Subject: LPC #0998995017 - LaSalle County
Wedron/Illinois Railway - Right-of-Way
LUST Incident No. 20130463

CDM Smith Inc. (CDM Smith) is submitting this letter in order to clarify comments posed by the Illinois Environmental Protection Agency (IEPA) and United States Environmental Protection Agency (USEPA) on our proposed work plan as submitted February 11, 2016.

Subject: LPC #0998995017 – LaSalle County
Wedron/Illinois Railway – Right-of-Way
LUST Incident No. 20130463

FIGURE 1
PROPOSED BORING/MONITORING WELL LOCATION
ILLINOIS RAILWAY
WEDRON, IL

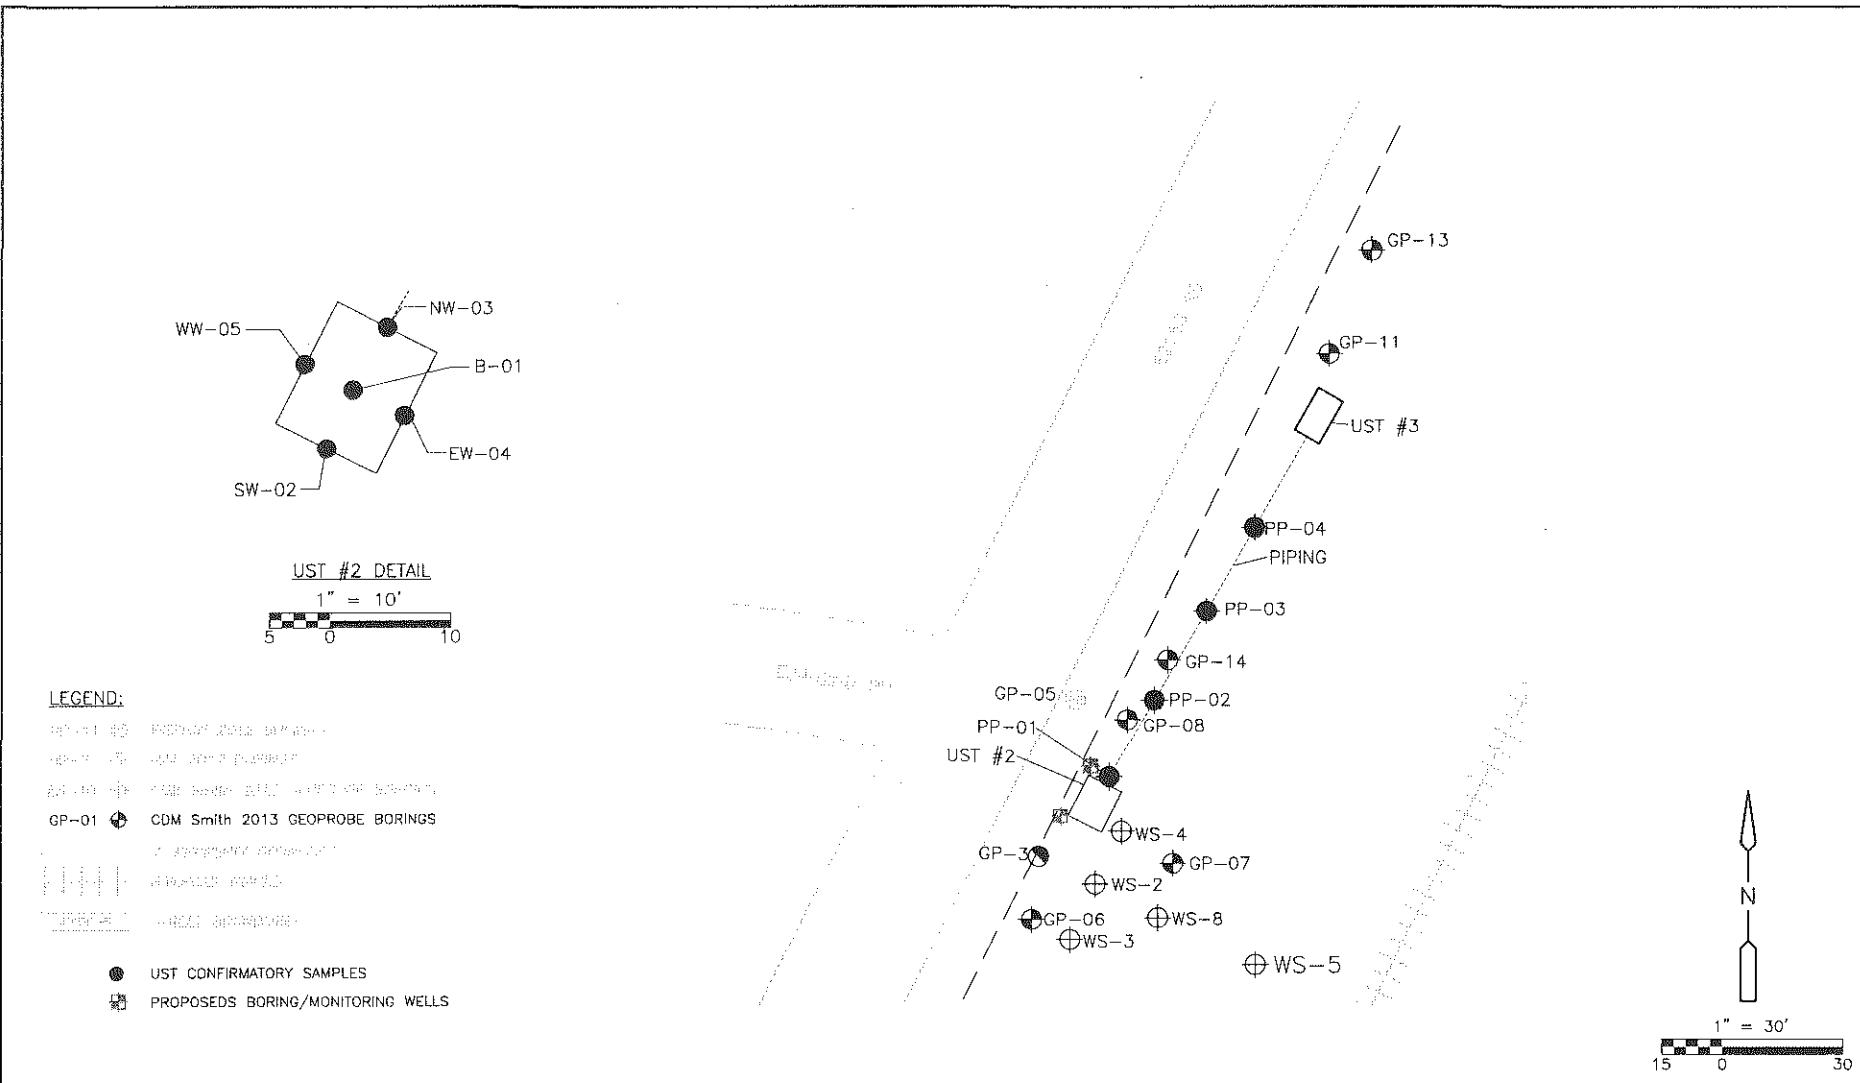
5C. IEPA/USEPA Comment: CDM should provide some justification for the locations if there has been some change from what they originally had discussed with IEPA. The plan is lacking in detail.

6C. IEPA/USEPA Comment: As you may recall, I believe only one (1) monitoring is required in a location west of the former UST and before the roadway. It's a much better location to collect soil and groundwater samples in order to determine the full extent of the contamination west of the former UST location. However, due to the nature of this site, it may be prudent to collect soil

But I thought we talked about advancing one (1) boring west of the former 500-gallon UST, instead of the two borings proposed in locations north and south of where we discussed. I understand this rip-rap is in the location that I want to advance a soil boring, so I have a few questions: Can the rip-rap be removed? And have you considered angular drilling?

The sample locations as indicated on the sample location map were as discussed with the IEPA due to the presence of the rip-rap. However, CDM Smith will work with the driller to either clear the rip-rap or otherwise complete the borings and monitoring wells west of the west wall of the former UST excavation area.

Two monitoring wells will be installed west of the former UST as indicated in the 1R. Response. Samples will be collected within each four-foot vertical soil interval.

Figure 2
Sample Location Map
Illinois Railway Property
Wedron, IL

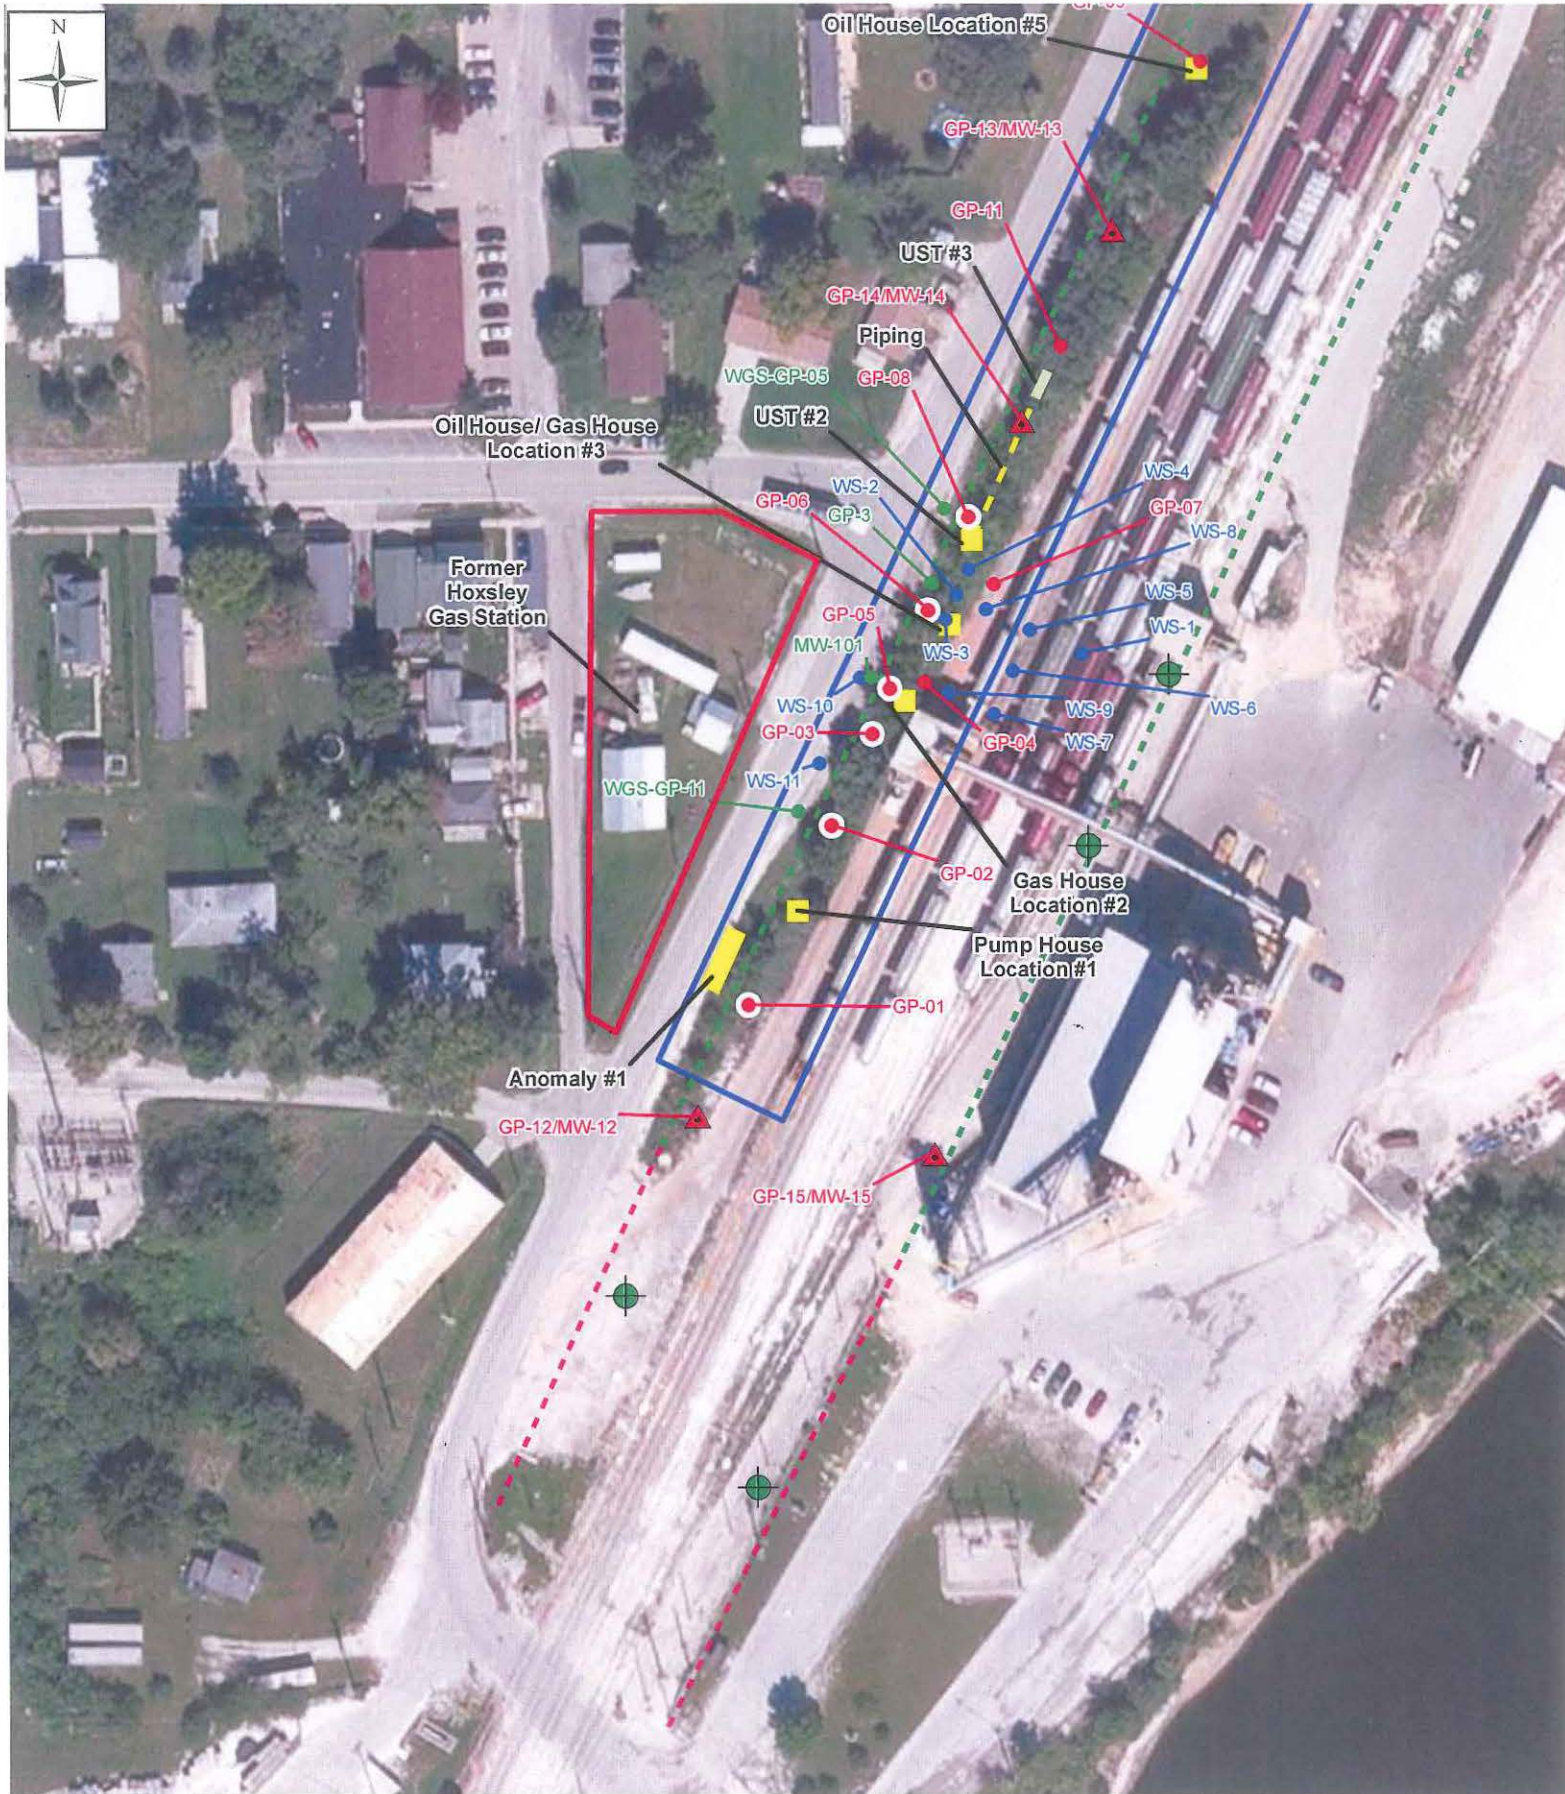
Illinois RR and their contractor CDM Smith have sent us a revised figure (figure 2) with proposed locations for the next step out sampling event. These locations are different from the first proposed locations and were changed on their behalf not from our comments. Please review and provide any comments you have by COB Tuesday Feb 17, 2015.

I just have one comment on the soil boring locations. The proposed boring in the SE corner appears to be close to a previous boring installed by Wedron Silica, GP14 on 5/8/14 (see attached pdf F10). Although the proposed boring does appear to be slightly south of GP14, I would just confirm with CDM Smith that it is at 10 or more feet south of GP14. The SE boring is meant to be approximately 100 feet south of GP-14.

I just have one comment on the soil boring locations. The proposed boring in the SE corner appears to be close to a previous boring installed by Wedron Silica, GP14 on 5/8/14 (see attached pdf F10). Although the proposed boring does appear to be slightly south of GP14, I would just confirm with CDM Smith that it is at 10 or more feet south of GP14.

I just have one comment on the soil boring locations. The proposed boring in the SE corner appears to be close to a previous boring installed by Wedron Silica, GP14 on 5/8/14 (see attached pdf F10). Although the proposed boring does appear to be slightly south of GP14, I would just confirm with CDM Smith that it is at 10 or more feet south of GP14.

Steve – after discussions with Ken and Randy, we have decided to eliminate the step-out boring protocols and just add two additional borings (GP-17 and GP-18) to the south end, just north of the railroad crossing (see attached Figure). GP-20 and GP-21 are in place to see the extent of contamination to the east. We would not complete additional step-out borings in this area, as we already have GP-15 in place to the south and a “clean” boring on the Wedron property to the north (as indicated in the attached Weston Figures 1A and 1B).
